PlanGrid Task Report - Jun 26, 2025

Prepared by Dale Wheeler

35 tasks in this report.

#23 [CNTL 017] [NEW] CRITICAL Thermostat terminations incorrect.

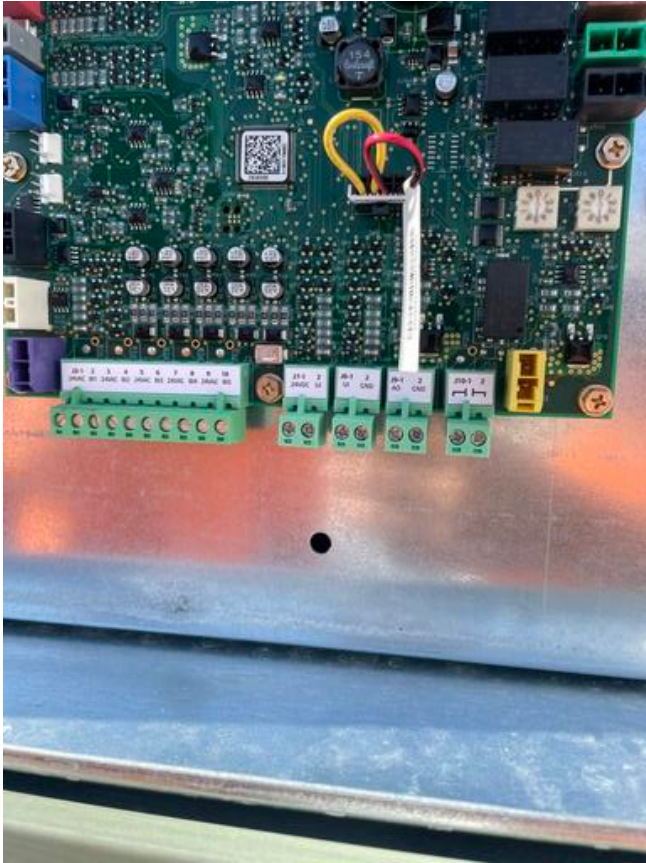
AC-1, 2, 3, 4, 5 terminal D-1 wire is not landed at terminal J-18 inside each unit.
